July 15, 2016

**BOARD OF COUNTY COMMISSIONERS
ORANGE COUNTY, FLORIDA**

**ADDENDUM NO. 3 / IFB NO. Y16-776-PH
INTERNATIONAL DRIVE POTABLE WATER BOOSTER PUMP STATION**

SCALE: 1" = 6'
 DRAWING NO.: **C103**
 SHEET: 9 OF 49

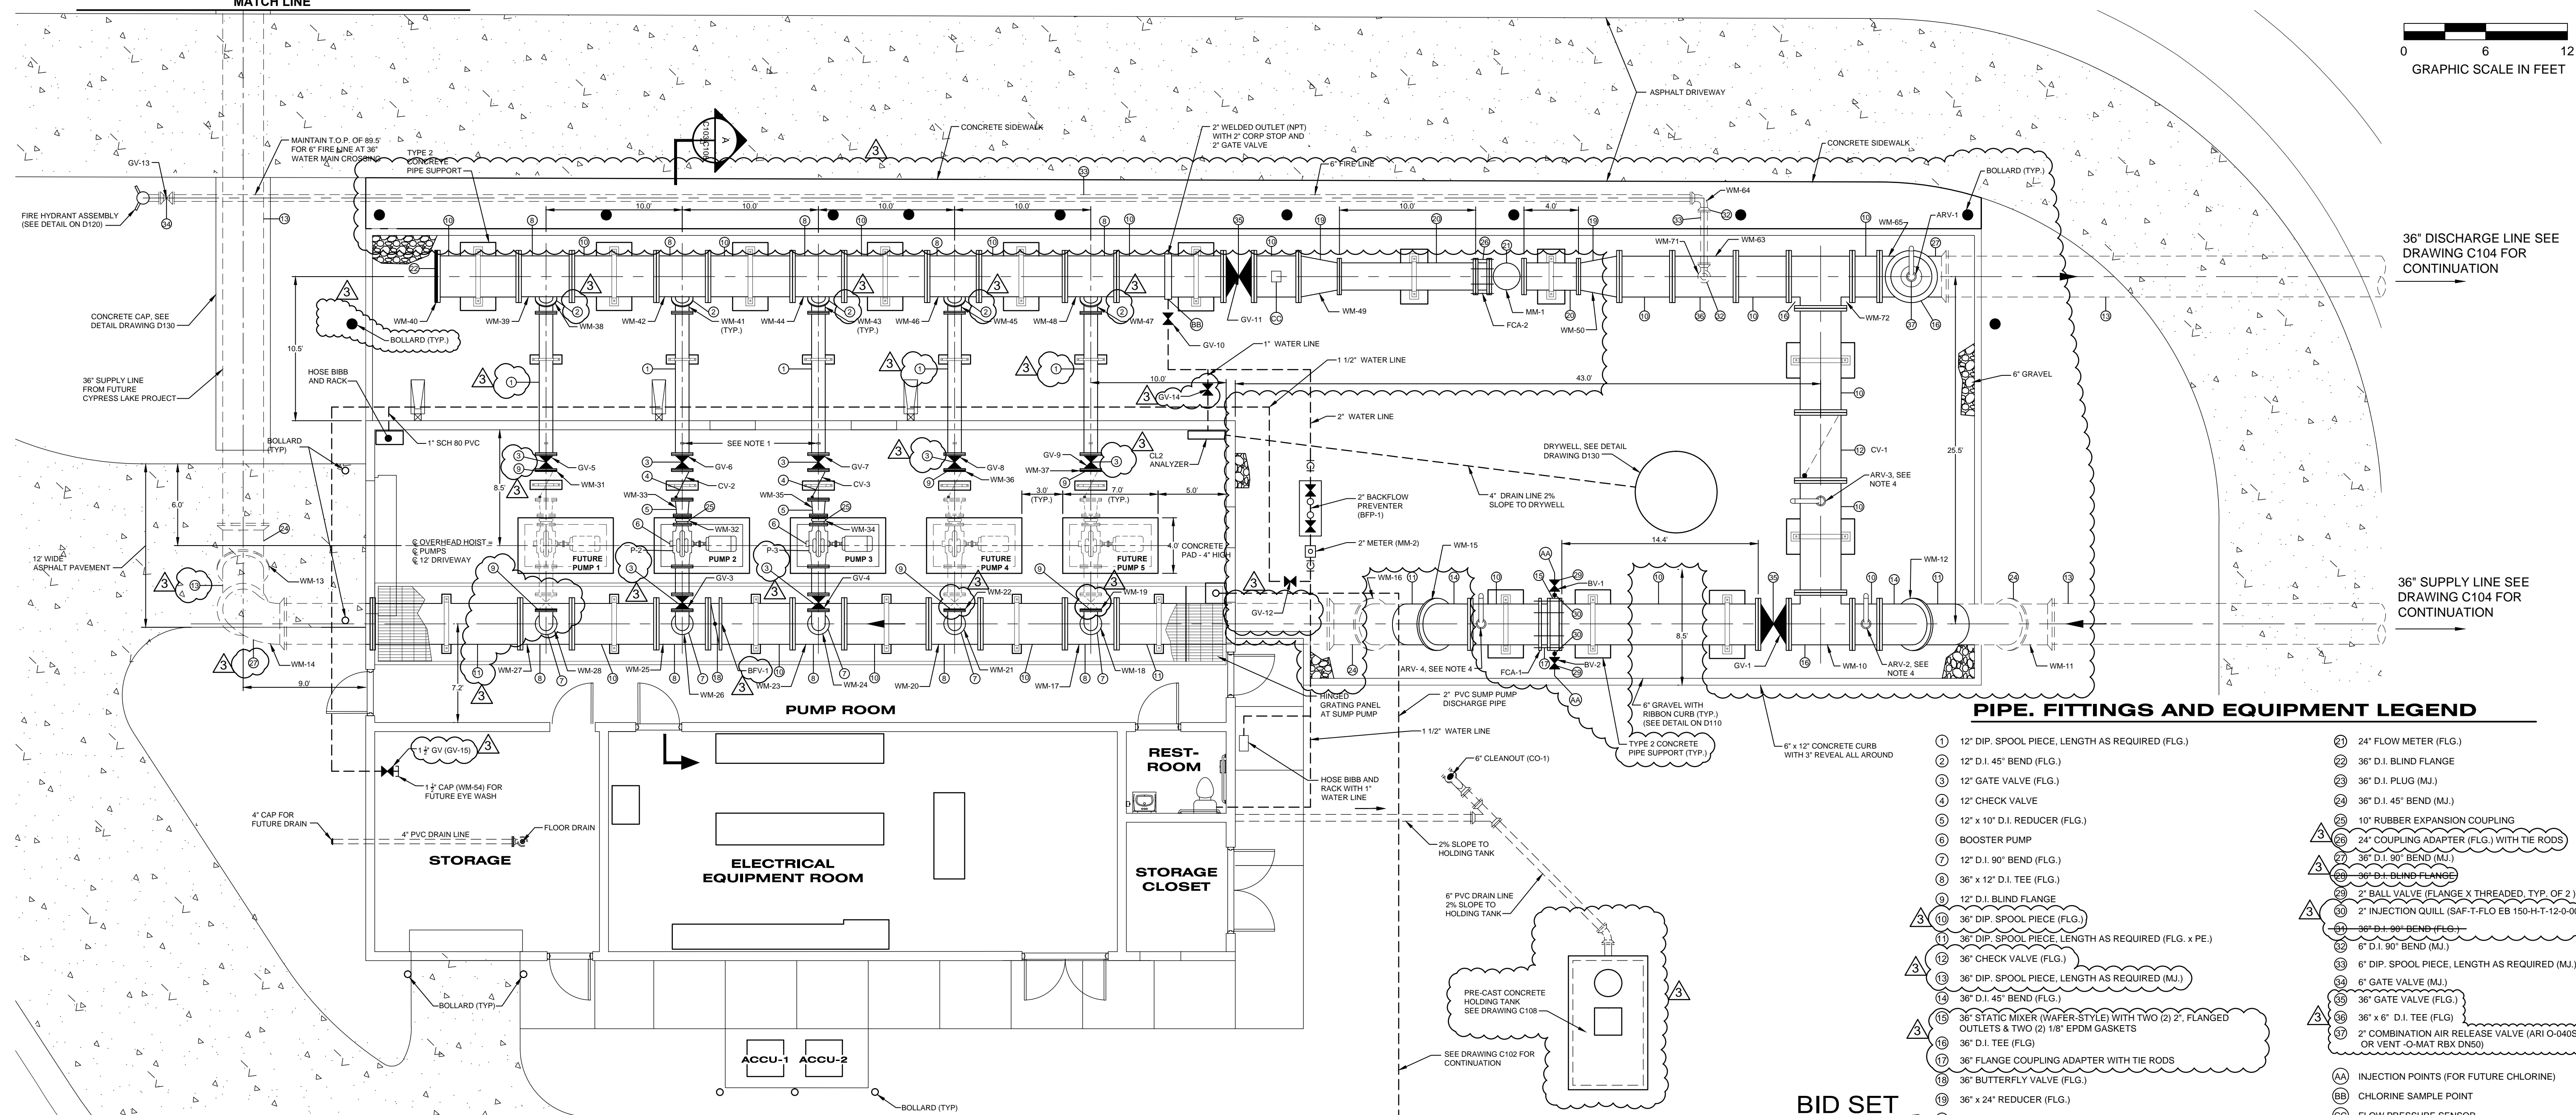
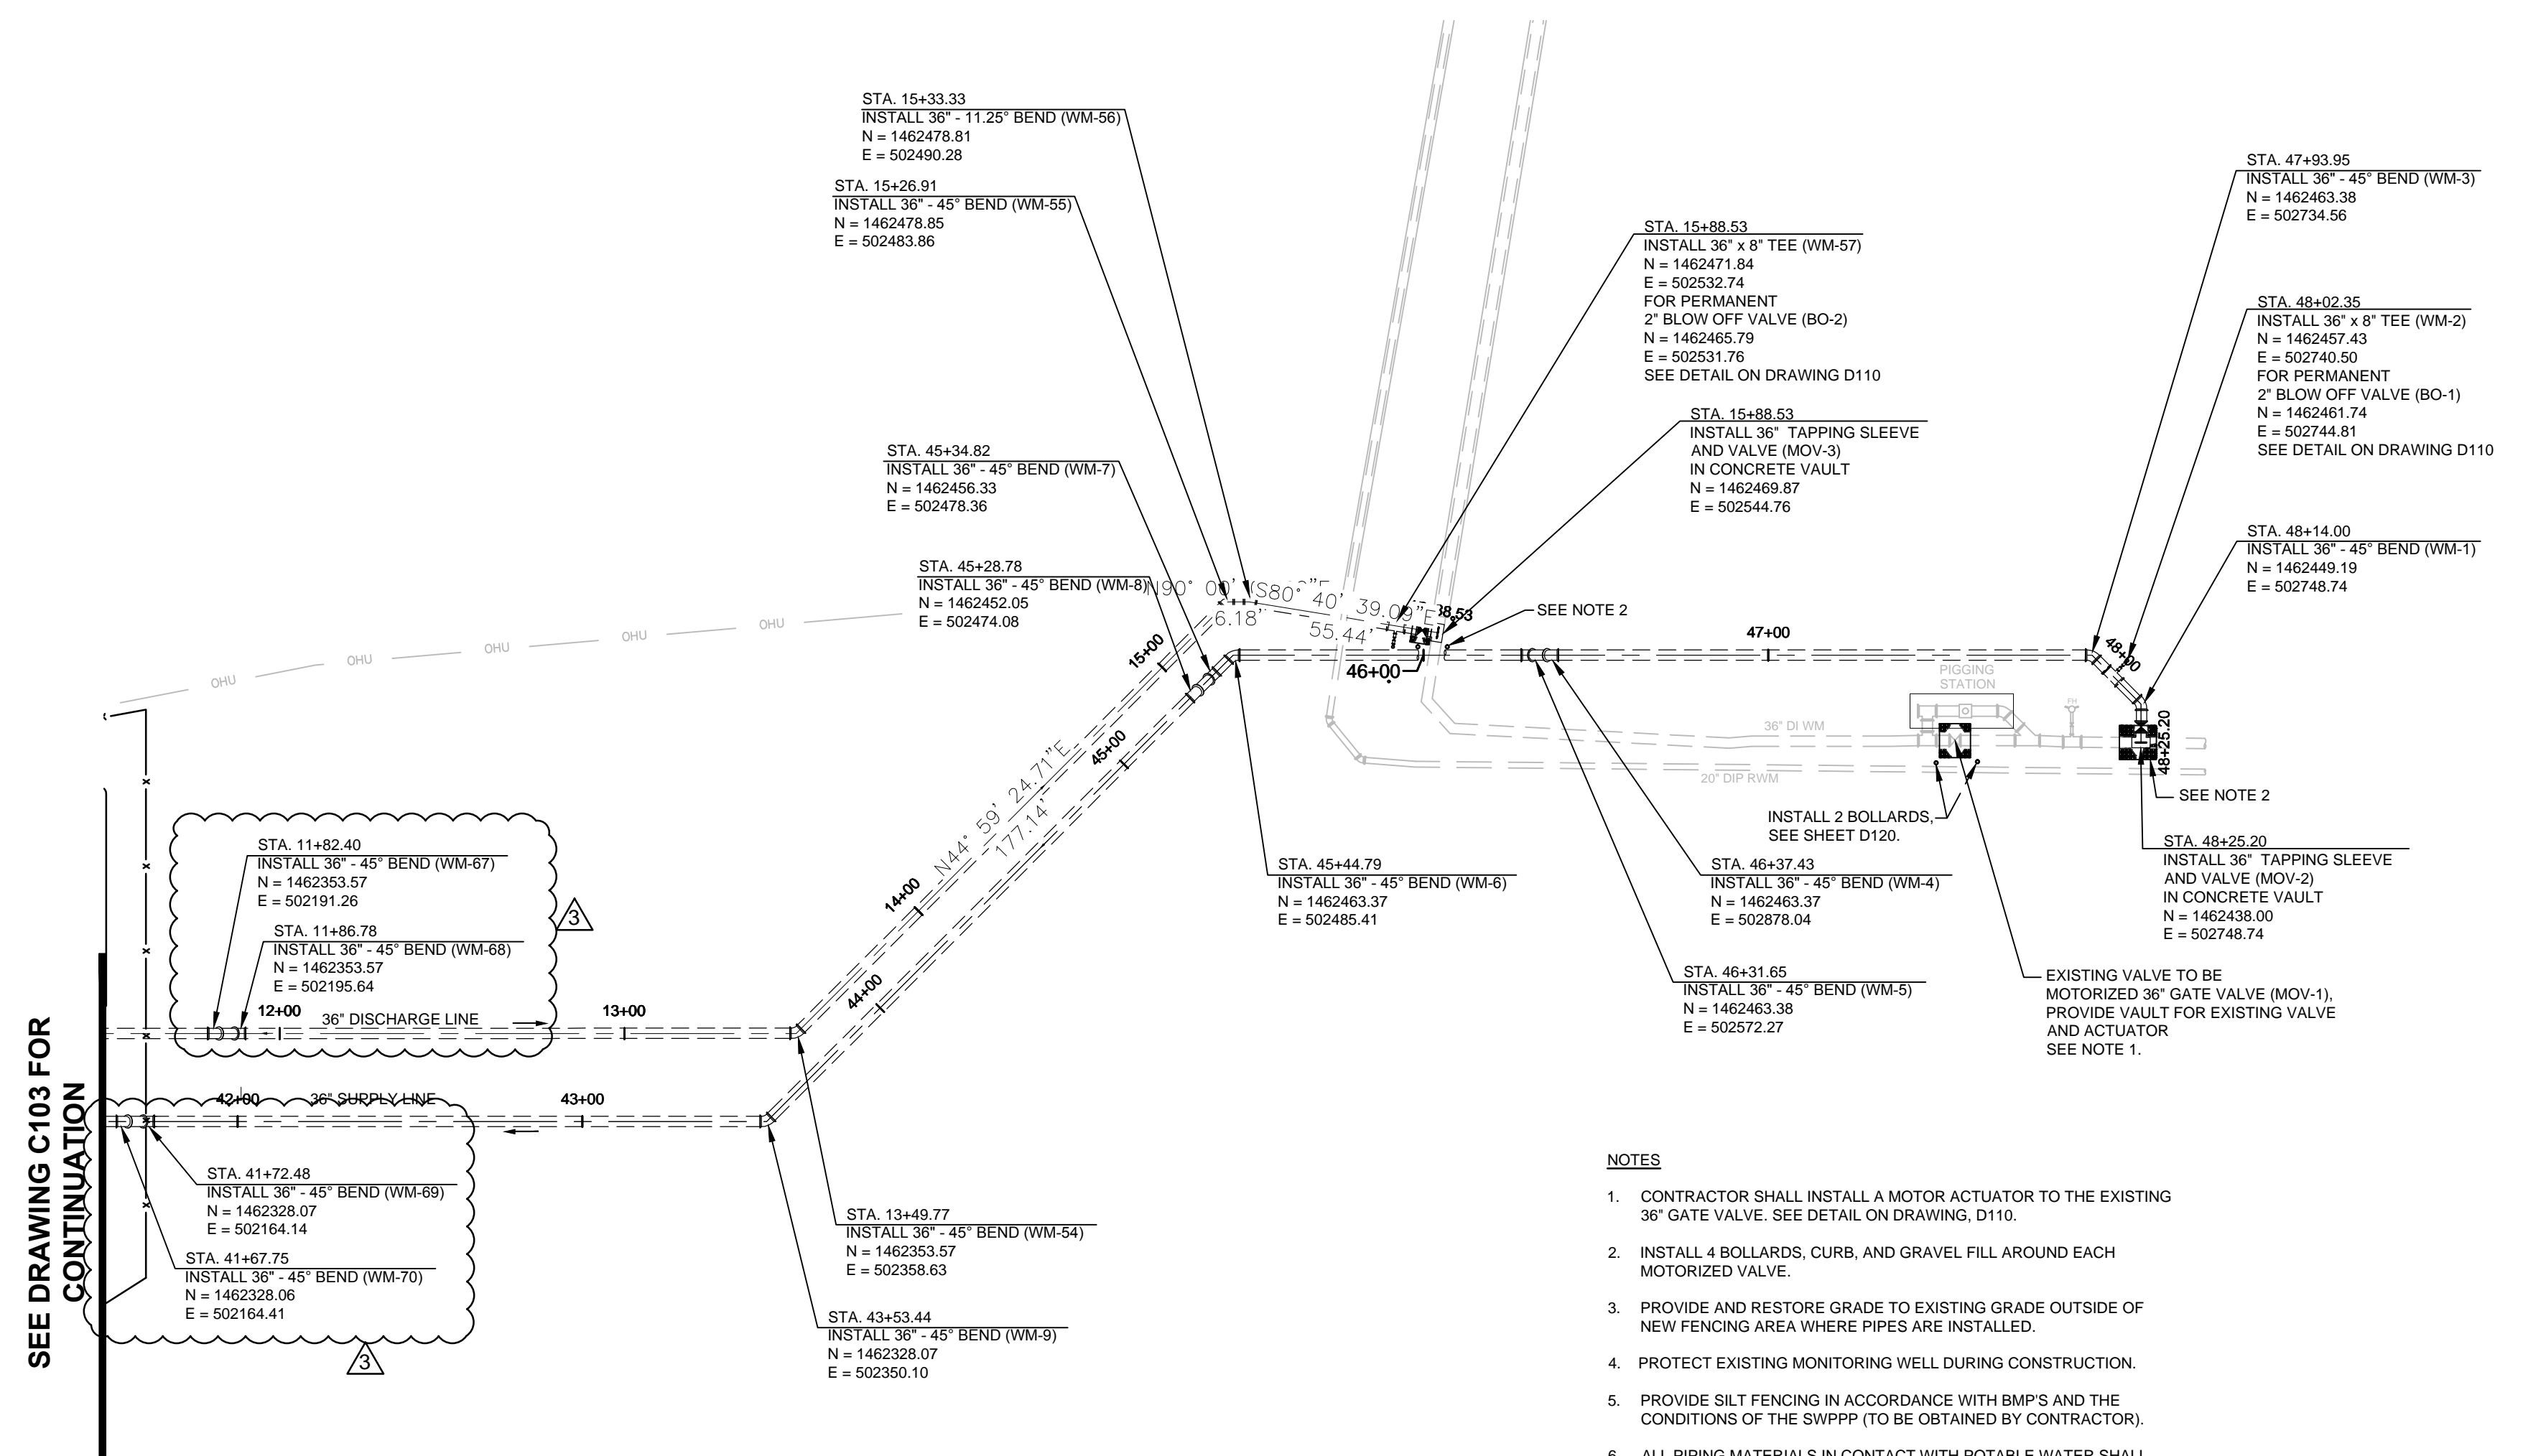
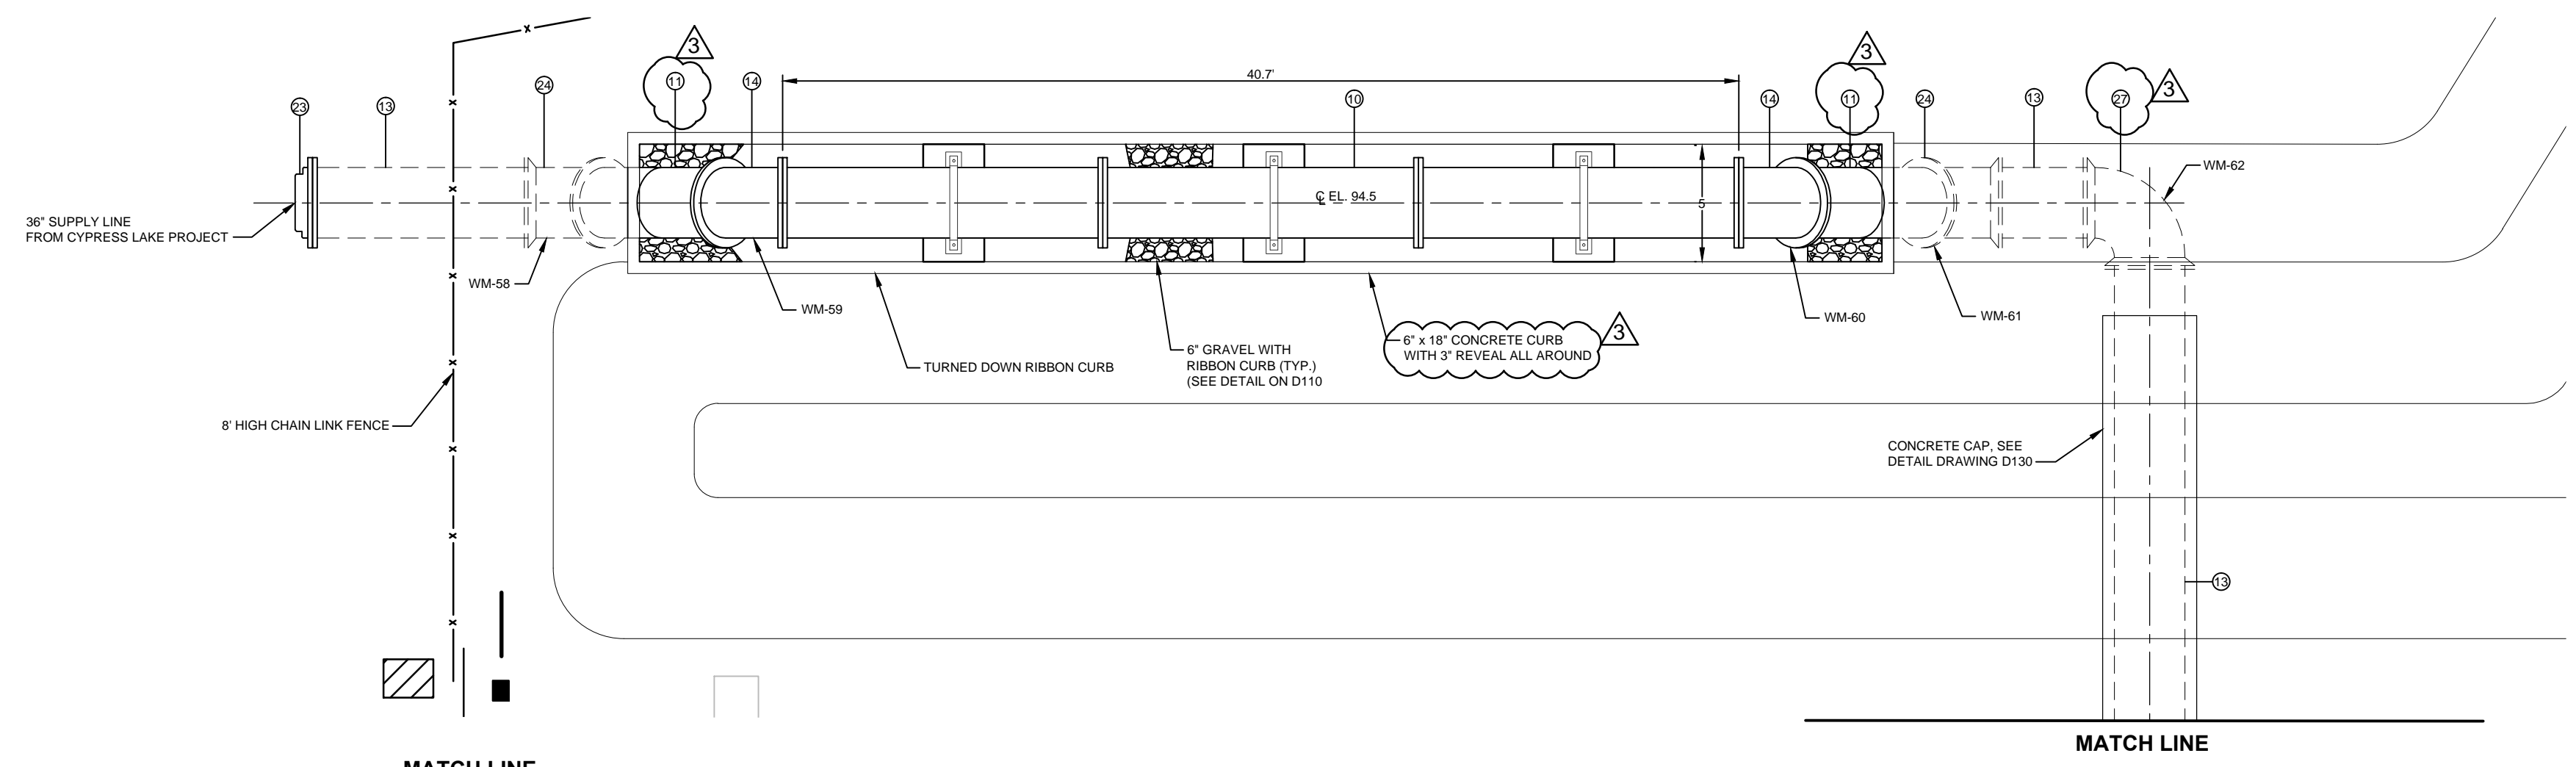
1. Q: Please clarify the 36" flanged valves? C103 calls for butterfly valves; C105 and C106 call for gate valves.

2. Q: The specified cushioned swing check valve for item 12 on C103 is not a product that can be buried. Please advise if a vault is required or an alternate product is desired.

- Modifications to the holding tank dimensions and manufacturer in order to meet FDOH permit requirements. See clouded revisions to Drawings C103 and C108.
- Updates to tags, identification numbers, callouts, and fitting locations where clouded. See clouded revisions to Drawings C103, C104, C105, C106, C107, C108, and X100.
- Deleted 36" blind flange callout (Item 28 on the Pipe, Fitting, and Equipment Legend on Drawing C103) and deleted associated Identification Number WM-29. See clouded revisions to Drawings C103 and X100.
- Revised 36" bypass pipe and 36" check valve above grade. Several other revisions to nearby fittings were also revised to be above grade. See clouded revisions to Drawings C103, C105, and C106.
- Added gravel and ribbon curb around modified 36" bypass pipe and check valve that were raised above grade. See revisions to C103.

- Added two additional 36" 45 degree bends to the discharge piping (see Drawing C105 and C107).
- Added size, manufacturer and model numbers to injection quills. See clouded revision to item 30 on the Pipe, Fitting, and Equipment Legend on Drawing C103.

- Added size, manufacturer and model numbers to air release valve. Relocated air release valve to new tee. See clouded revision and added Item 37 on the Pipe, Fitting, and Equipment Legend on Drawing C103. Also, see revisions to Drawing C105 showing new air release valve location.

- Added additional requirements to the static mixer. See revisions to Item 15 in the Pipe, Fitting, and Equipment Legend on Drawing C103.
- Added additional bollards to Drawing C103.

A: Two 36" flanged gate valves should be provided outside the building – one on the suction piping and one on the discharge piping. The labels have been corrected on the attached revised Drawing C103. A single 36" butterfly valve should be provided on the suction piping between pumps 2 and pump 3 and is labeled correctly on Drawing C103.

A: The 36" bypass pipe and 36" check valve and all associated fittings and appurtenances have been revised to be installed above grade. Attached are the revised Drawings associated with this change (Drawings C103, C104, C105, C106, and X100).
